Wisconsin Department of Transportation

**Proposal #32: 6360-05-75, WISC 2026108
V Marathon City, Main Street
CTH B to North Street
STH 107
Marathon County**

This is Addendum No. 01, which provides for the following:

PIPE UNDERDRAIN

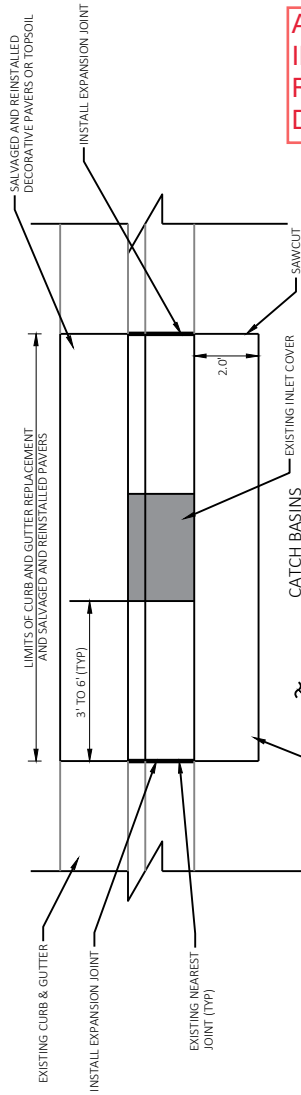
Revised Plan Sheets	
Plan Sheet	Plan Sheet Title (brief description of changes to sheet)
14	Pipe Underdrain detail updated to show Asphaltic Surface is required in lower layer instead of HMA 4 MT 58-28 H

- NOTES
- ① 5.5" HMA PAVEMENT
 - 1.75" 4 MT 58-28 H (UPPER LAYER)
 - 3.75" ASPHALTIC SURFACE (LOWER LAYER)
